Ketchum / SVWSD Water Reclamation Facility  
Aeration Upgrades

**ADDENDUM NO. 3**

February 21, 2024

CONTRACTOR TO FIELD-FABRICATE TEMPORARY CANOPY OVER TEMPORARY BLOWER INSTALLATION. CONTRACTOR SHALL SUBMIT CANOPY DESIGN. DESIGN PER LOADS ON STRUCTURAL GENERAL NOTES S-001.

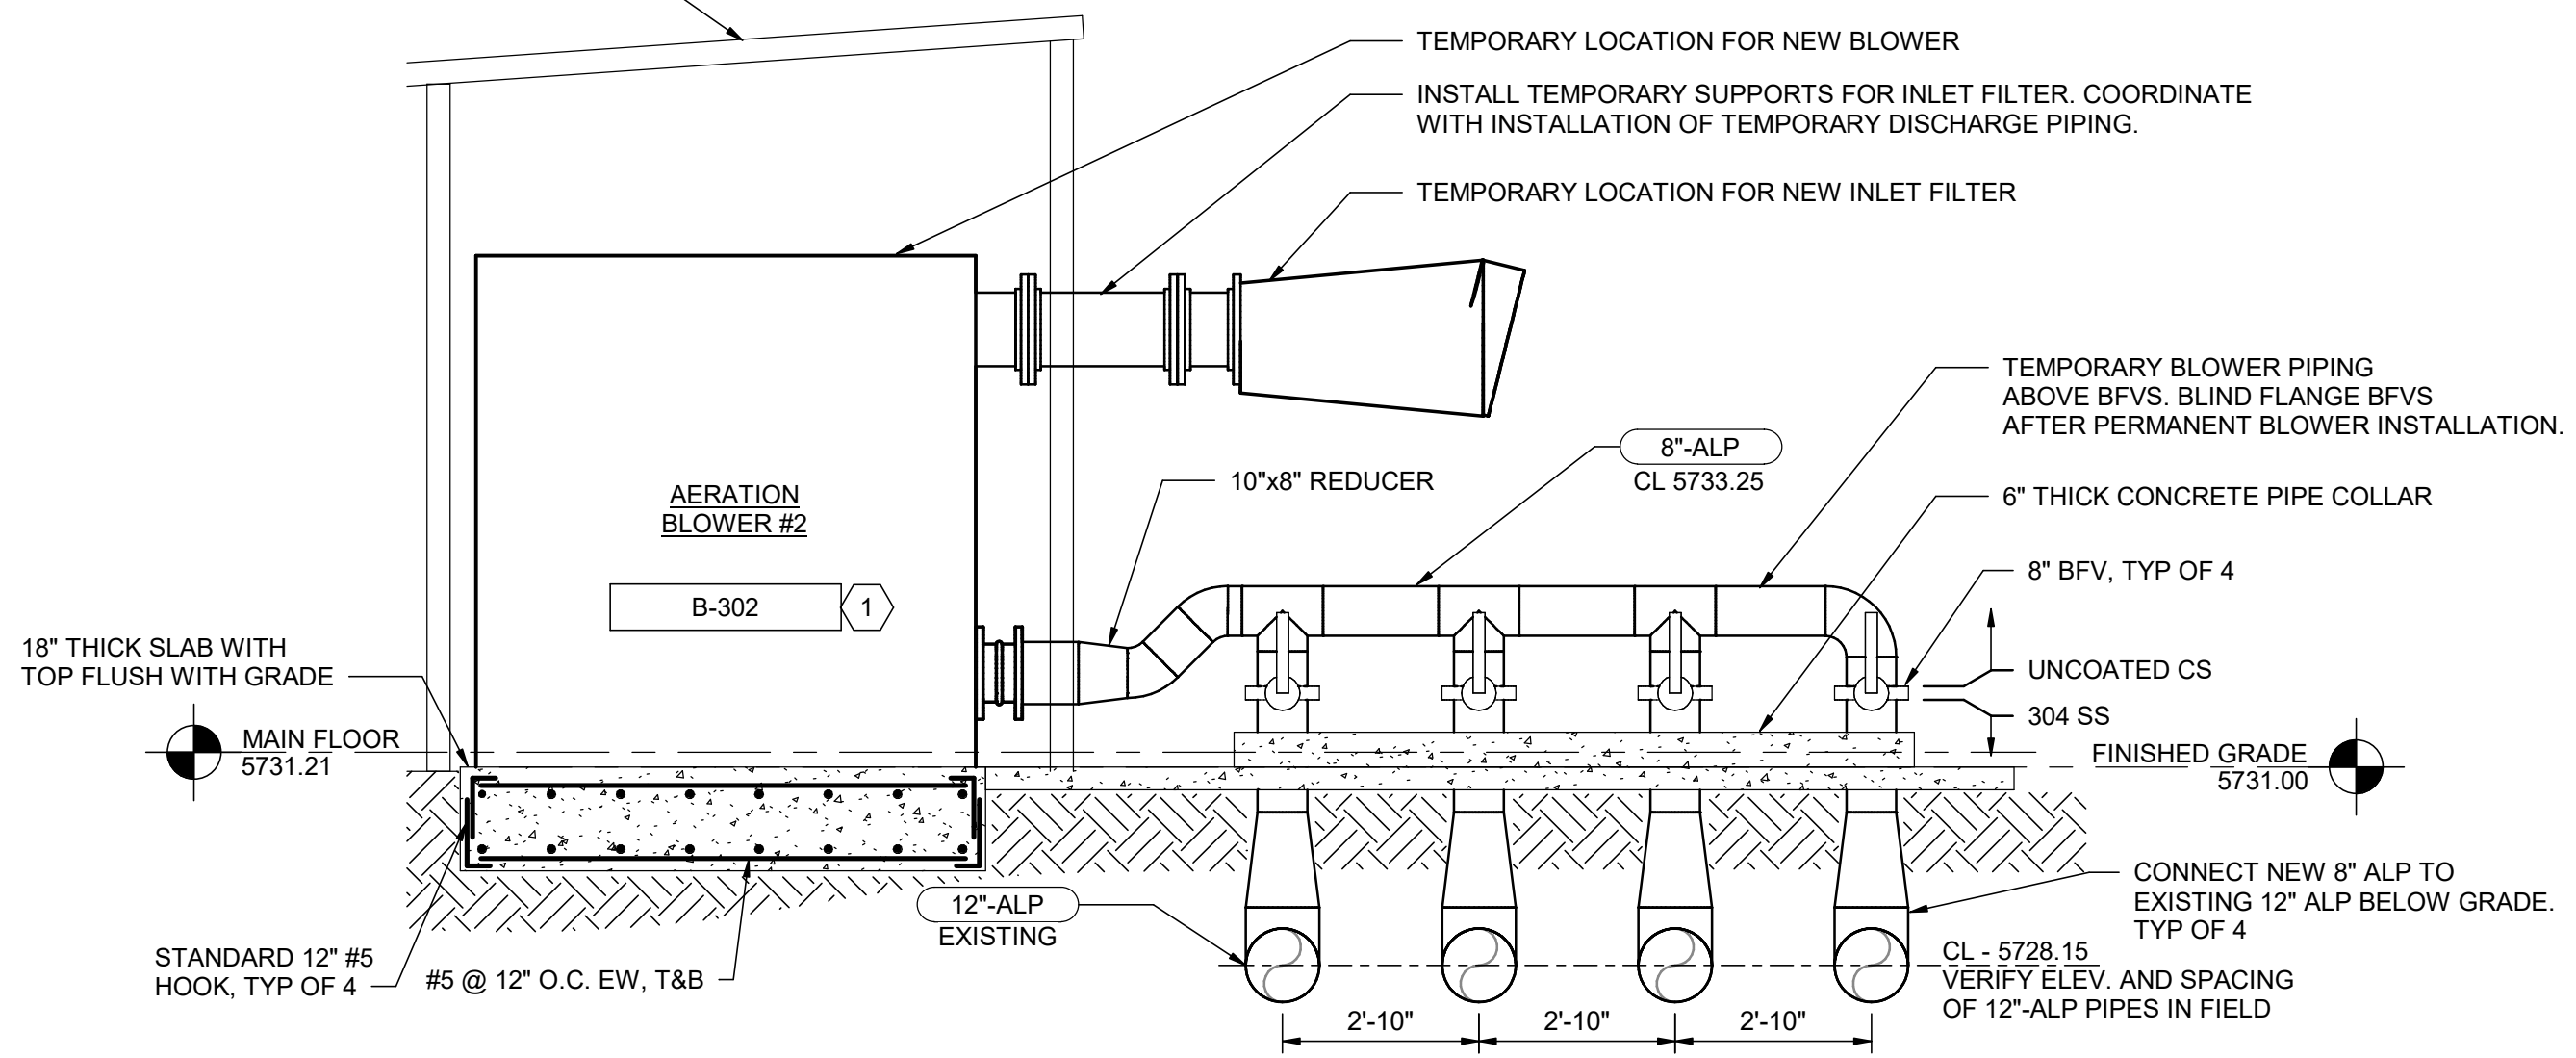
3.09 Drawing D-301: Process - Blower Building Aeration Blower Sections: Modify the Drawings as shown by Addendum No. 3 revision.

**PROCESS  
FLOATING MIXER AND MLR PUMP  
SECTIONS**

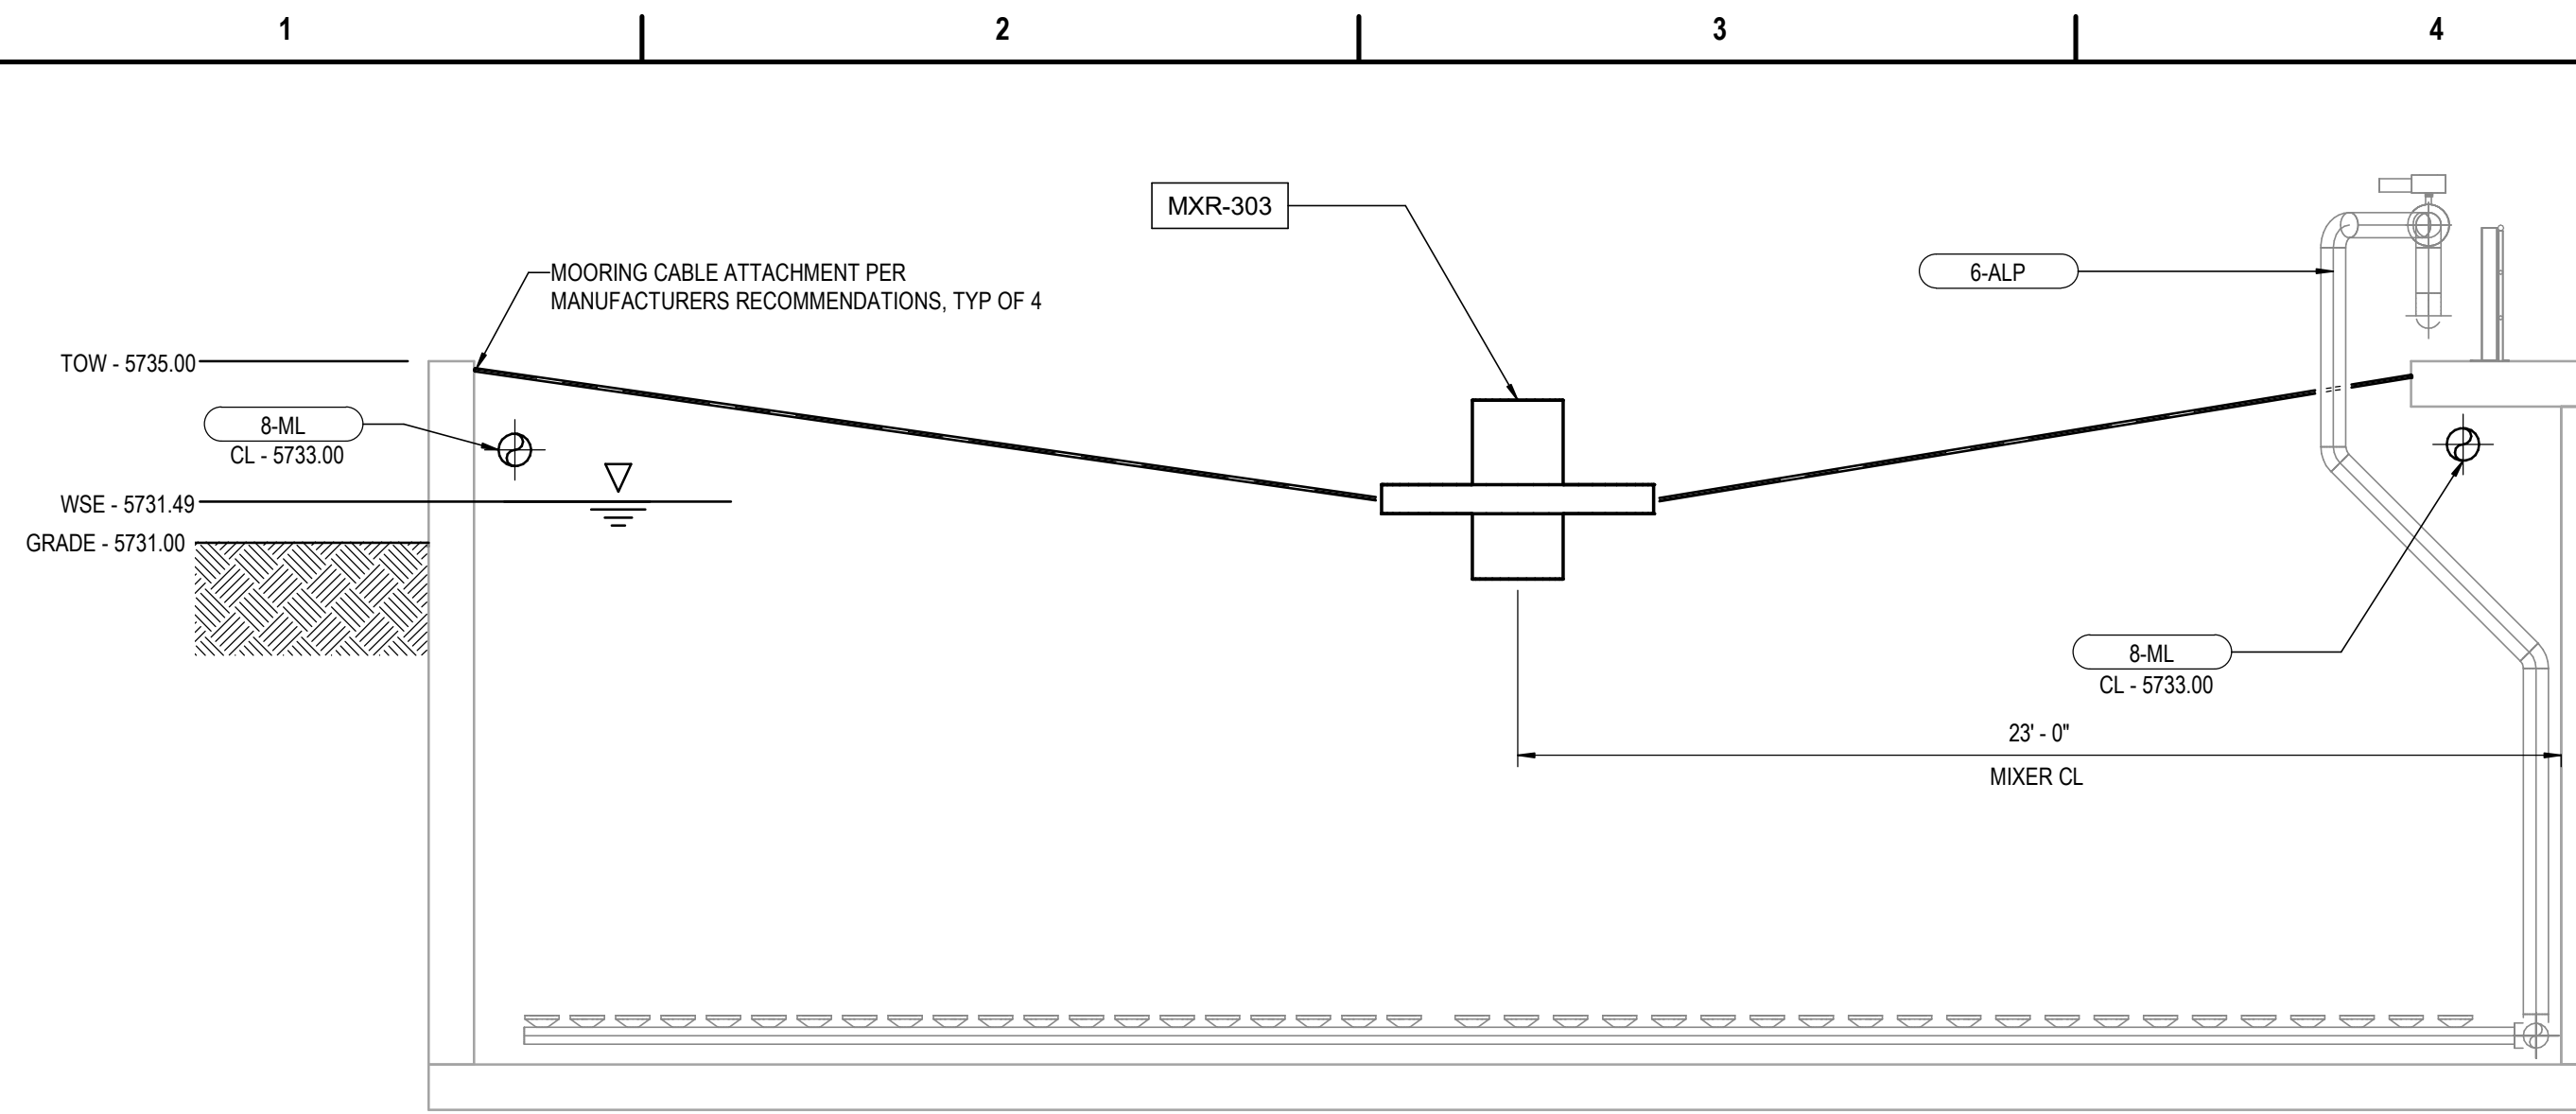
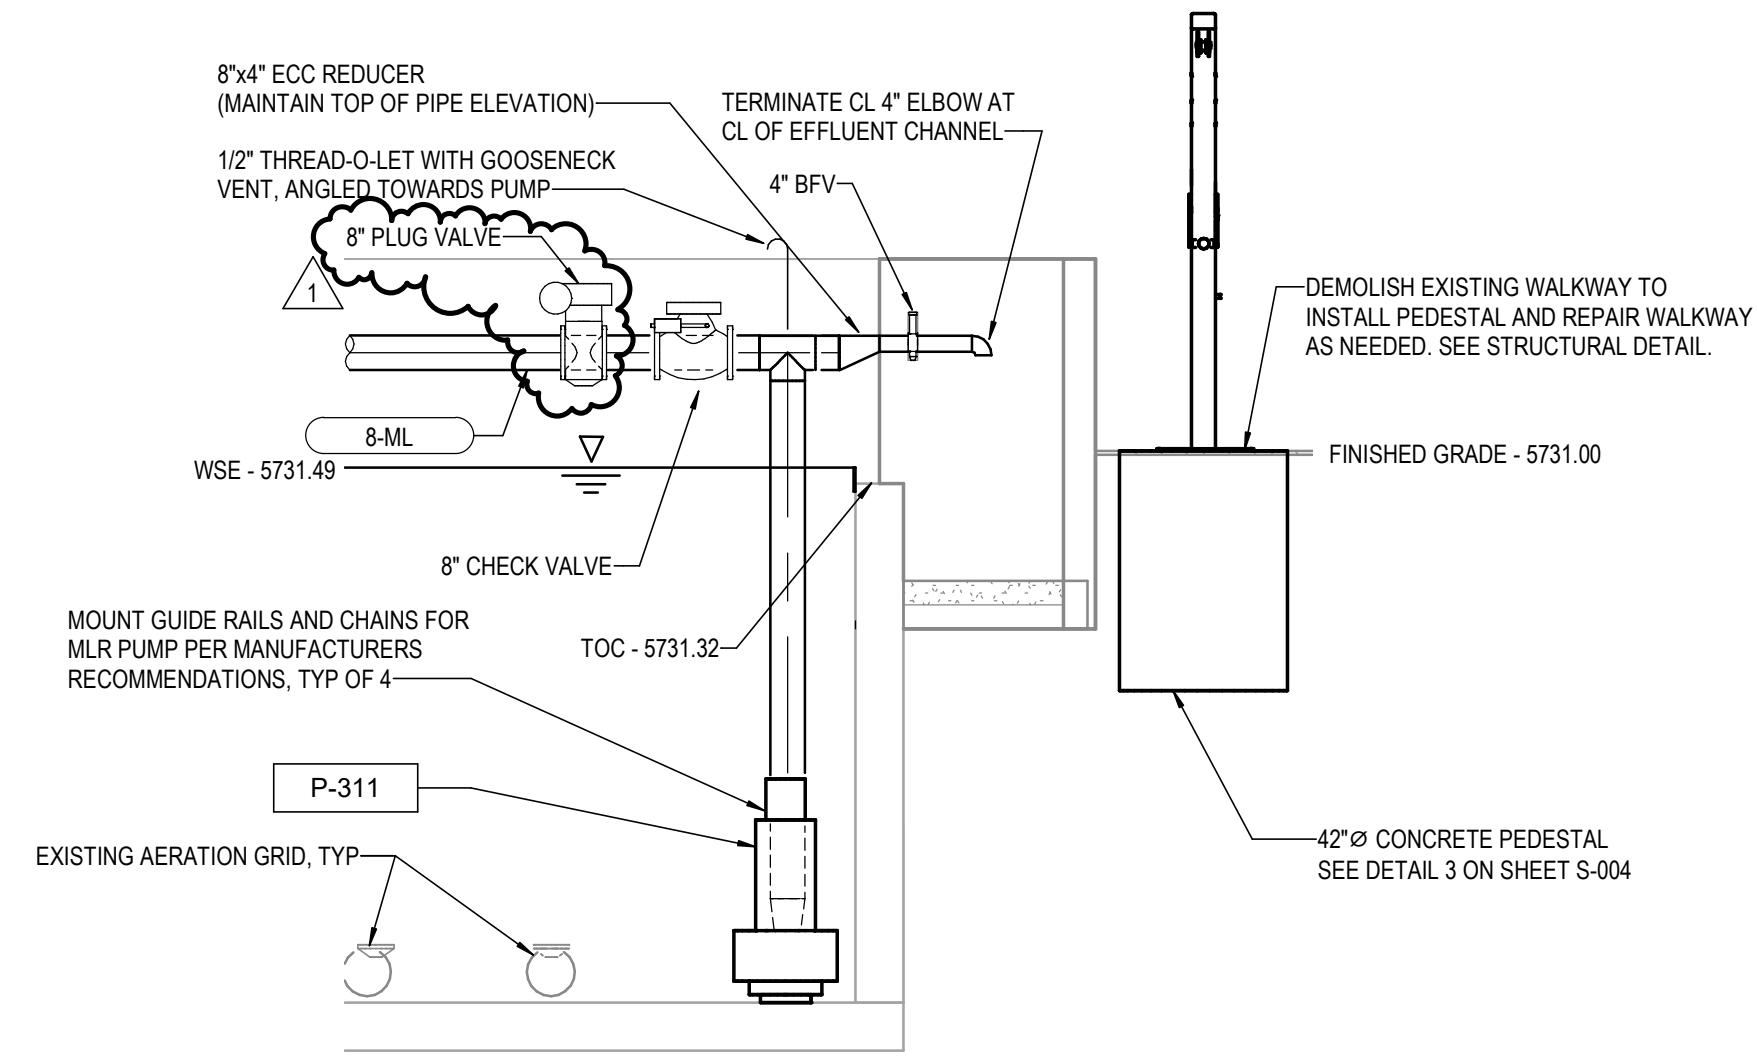
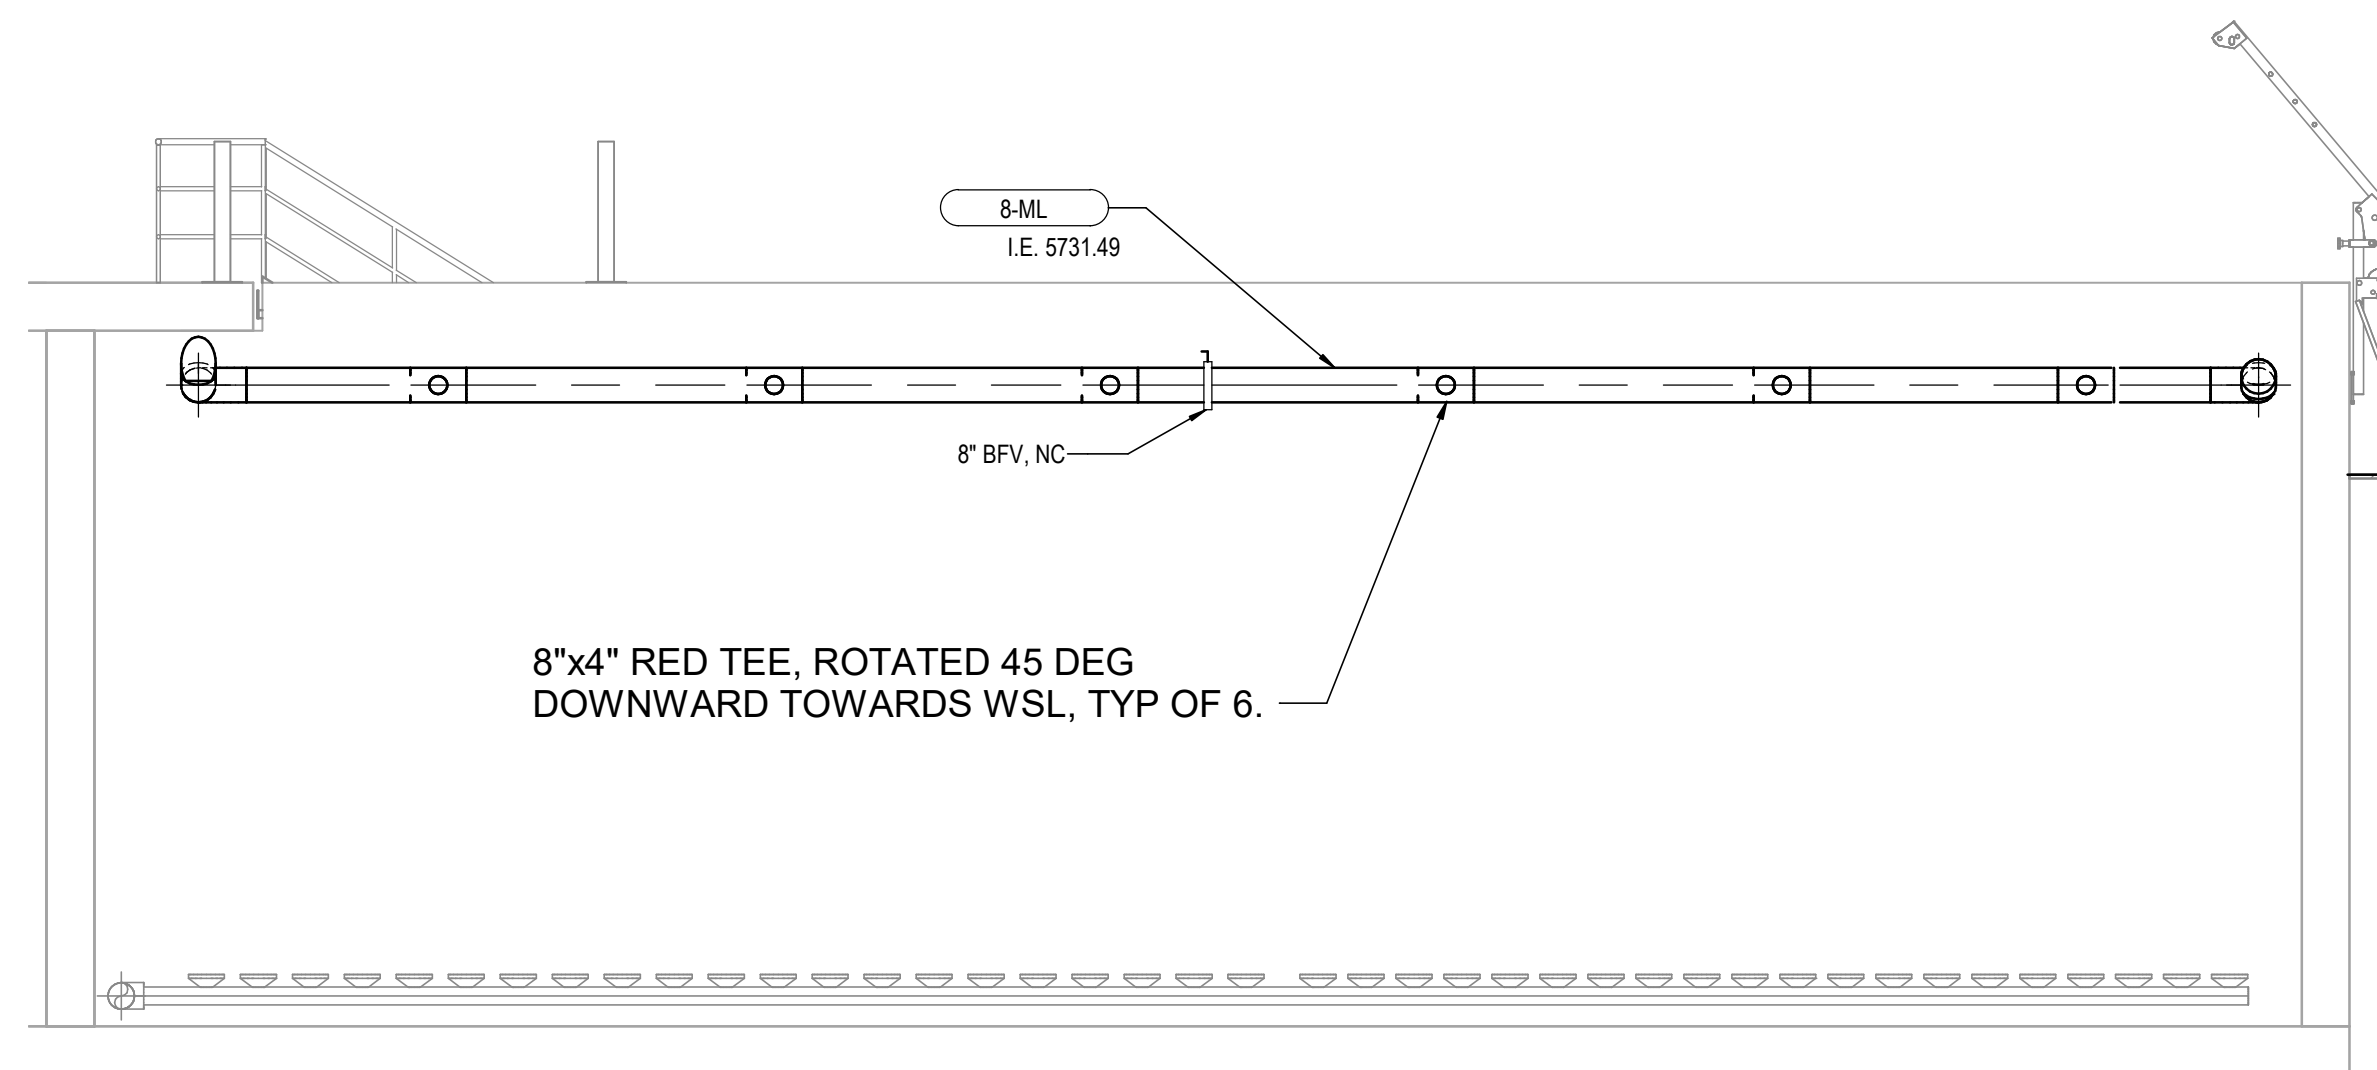
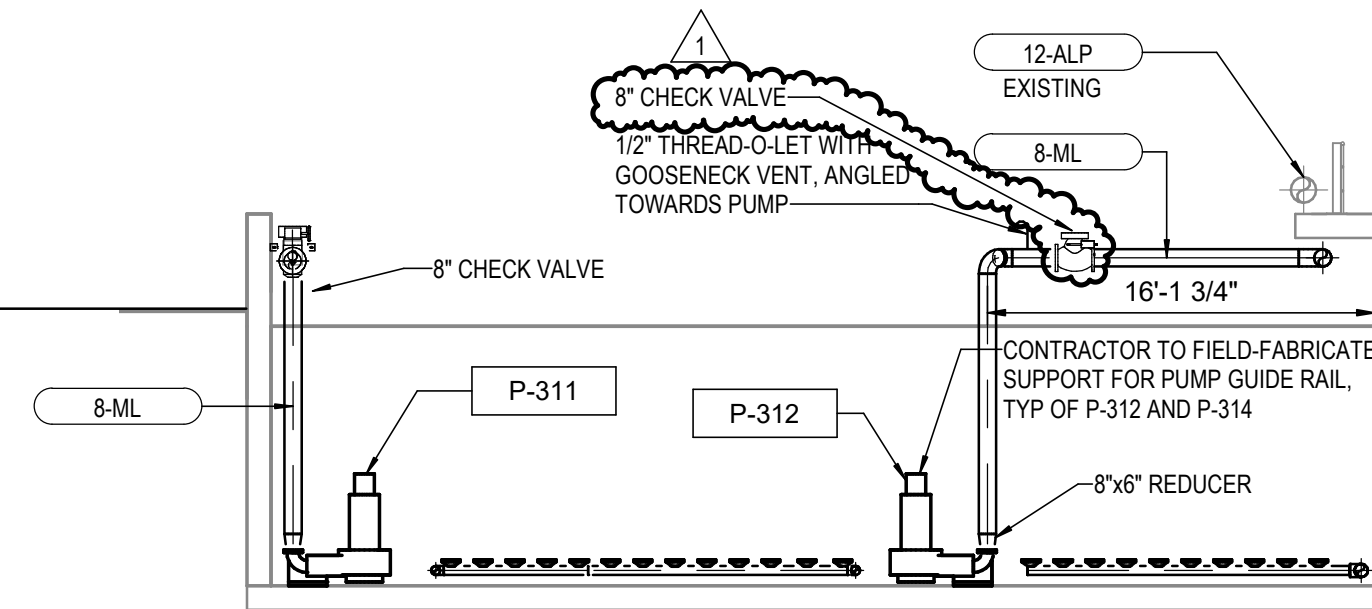
3.10 Drawing D-302: Process - Floating Mixer and MLR Pump Sections: Modify the Drawings as shown by Addendum No. 3 revision.
